NUMBER 110

SUBJECT: WINDSHIELD ATTACHMENT

MODELS AFFECTED: PIPER AIRPLANES MODELS PA-15 SERIAL NUMBERS 15-1 TO 15-387 INCL., AND PA-17 SERIAL NUMBERS 17-1 TO 17-214 INCL.

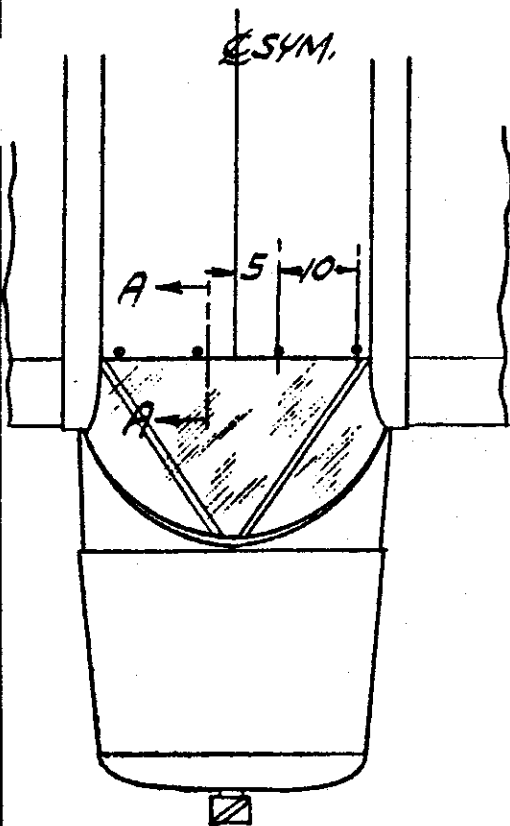
In order to eliminate the possibility of the windshield coming out of its top retaining channel (channel located on tube between front wing hinge fittings) it is strongly recommended that the windshield attachment be reworked to incorporate the use of four machine screws installed in accordance with the sketch below.

NOTE
DO NOT FORCE DRILL THRU PLEXIGLAS
